QUALITY ASSURANCE -- NON-CONFORMANCE REPORT

Location: Changxing Island, Shanghai, P.R. China **Report No:** NCR-000305
Prime Contractor: American Bridge/Fluor Enterprises, a JV **Date:** 10-Jun-2009
Submitting Contractor: Zhenhua Port Machinery Company, Ltd (ZPMC), Changxing Island **NCR #:** ZPMC-0279

Reference Description: Missed MT Indication by QC, Plate X195B, Segment 1AAW

To:	AMERICAN BRIDGE/FLUOR, A JV 375 BURMA ROAD OAKLAND CA 95607	**Date:**	14-Jun-2009
		Contract No:	04-0120F4 04-SF-80-13.2 / 13.9
Dear:	Mr. Charles Kanapicki	**Job Name:**	SAS Superstructure
Attention:	Mr. Thomas Nilsson Project/Fabrication Manager	**Document No:**	05.03.06-000269
Subject:	NCR No. ZPMC-0279

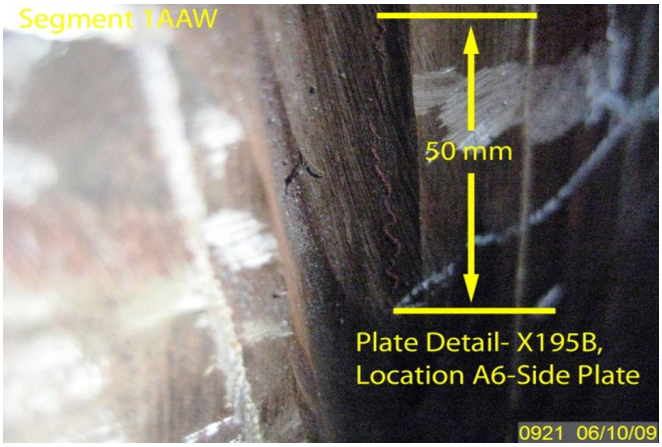
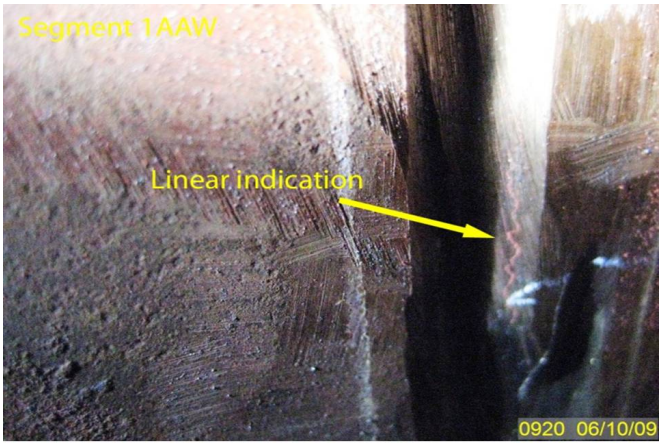
During random verification magnetic particle testing (MT) of the internal components of OBG Segment 1AAW, Caltrans Quality Assurance (QA) Inspector discovered a linear indication approximately 50mm in length in the base metal where a weld had been removed on A6 side plate X195B. This area was previously tested and accepted by ZPMC Quality Control (QC) MT technicians.

The proposed resolution is acceptable. The welds in question have been accepted by VT and MT as shown in the attached documents. The Department concurs that Non-Conformance ZPMC-0279 is closed.

Reference Description: Missed MT Indication by QC, Plate X195B, Segment 1AAW

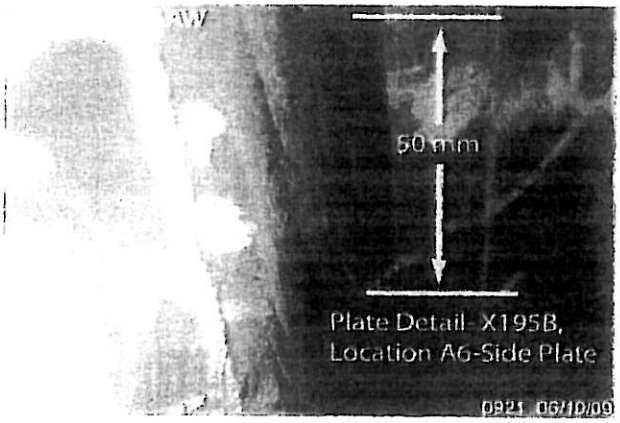
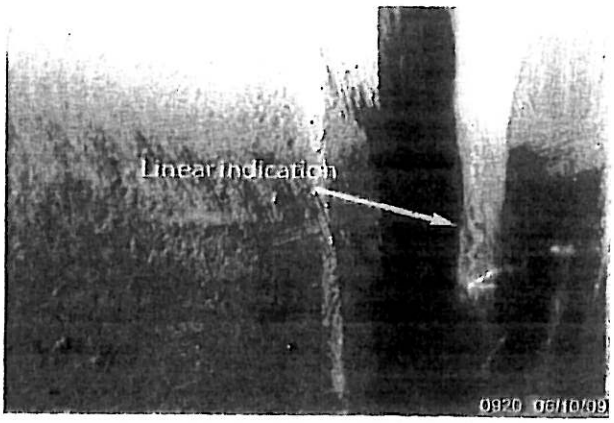
During random verification magnetic particle testing (MT) of the internal components of OBG Segment 1AAW, Caltrans Quality Assurance (QA) Inspector discovered a linear indication approximately 50mm in length in the base metal where a weld had been removed on A6 side plate X195B. This area was previously tested and accepted by ZPMC Quality Control (QC) MT technicians.

Reference Description: Missed MT Indications by QC, Plate X182B, Segment 1AAW

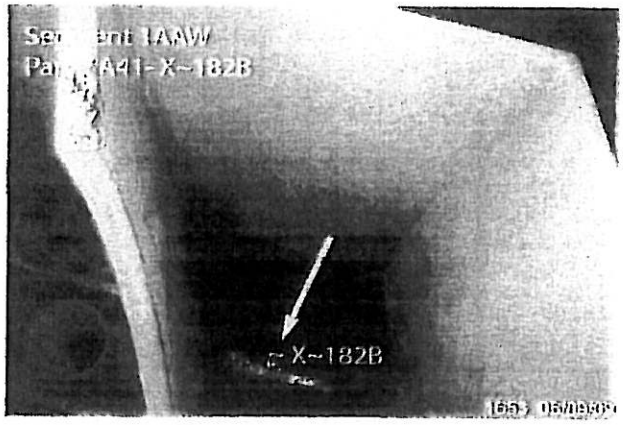
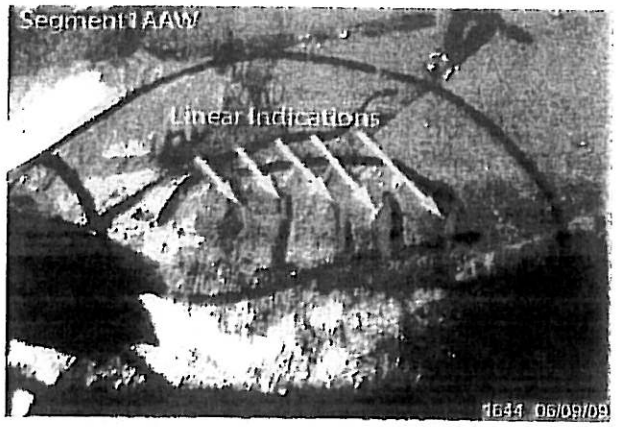
During random verification magnetic particle testing (MT) of the internal components of OBG Segment 1AAW, Caltrans Quality Assurance (QA) Inspector discovered a total of five (5) linear indications ranging from 5 to 15mm in length in the base metal where weld had been removed on Plate X182B. These welds have been previously tested and accepted by ZPMC Quality Control (QC) MT technicians.

Reference Description: Missed MT Indications by QC, Plate X199A, Segment 1AAW

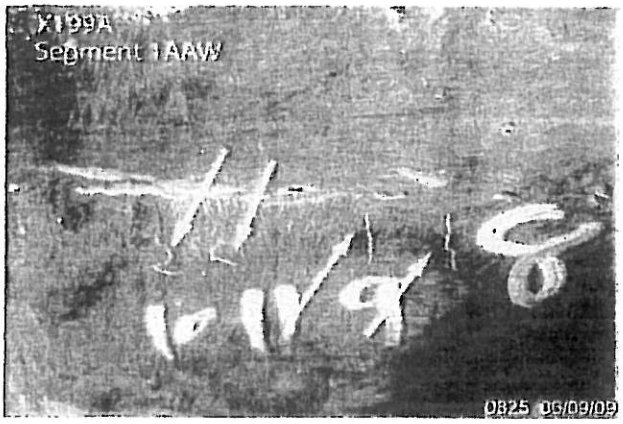
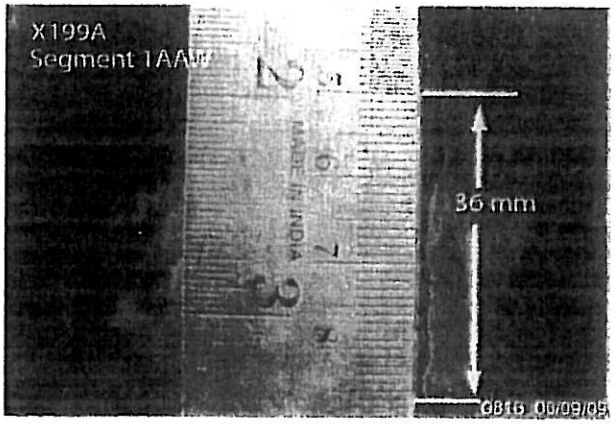
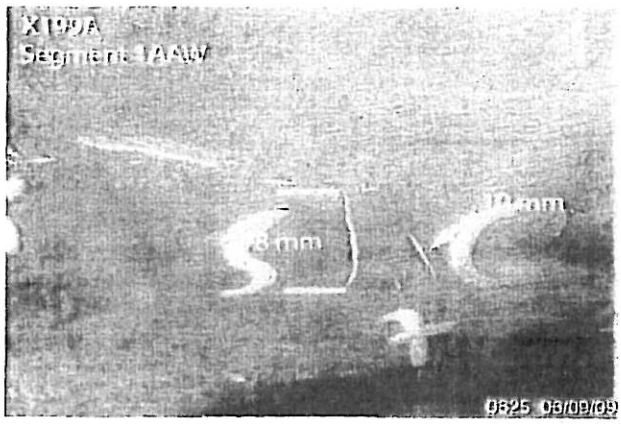
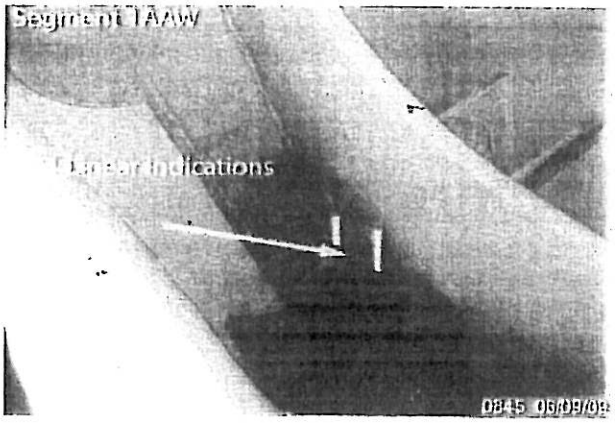
During random verification magnetic particle testing (MT) of the internal components of OBG Segment 1AAW, Caltrans Quality Assurance (QA) Inspector discovered a total of eleven (11) linear indications ranging from 5 to 35mm in length in the base metal where weld had been removed on Plate X199A. These welds have been previously tested and accepted by ZPMC Quality Control (QC) MT technicians.

Reference Description: Missed MT Indications by QC, Plate X181A, Segment 1AAW

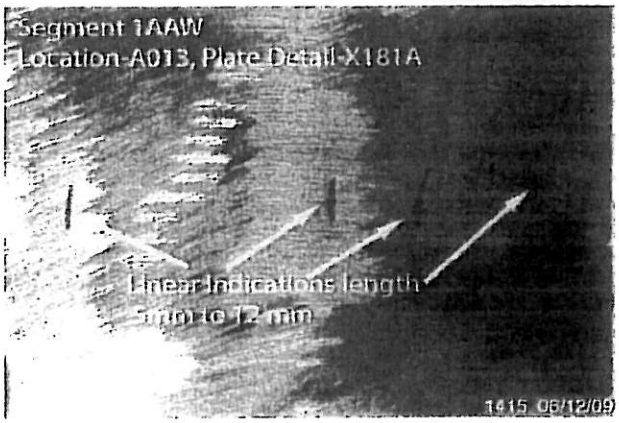
During random verification magnetic particle testing (MT) of the internal components of OBG Segment 1AAW, Caltrans Quality Assurance (QA) Inspector discovered a total of four (4) linear indications ranging from 5 to 12mm in length in the base metal (weld removal area) at location A13, plate X181A. These areas have been previously tested and accepted by ZPMC Quality Control (QC) MT technicians.

Draft of Welding Discontinuity:

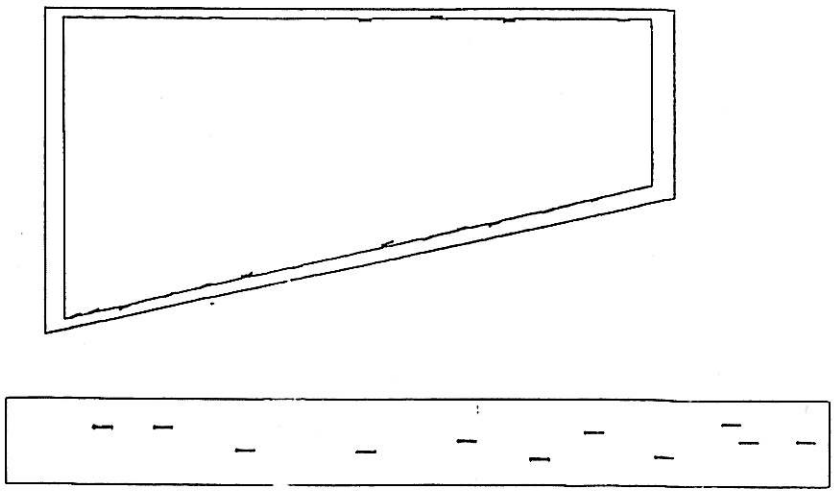
Please see the detail data from MT report!

1. Remove the crack by means of grinding.
2. Prepare excavation according to the approved repair WPS.
3. Grind the area to a smooth and shiny finish, with tapered ends, to ensure staggered starts and stops.
4. Verify with VT and MT repair areas are crack free before welding.
5. Preheat and weld according to the approved repair WPS.
6. Preheat prior to welding to a minimum temperature of 100℃ or what's required in the approved WPS, whichever is higher.
7. The preheat area shall be a minimum of 150mm in all directions around the repair area.
8. Grind the repaired area flush with base metal or the adjacent weld.
9. Perform VT UT and MT of the repair areas. per the contract requirement
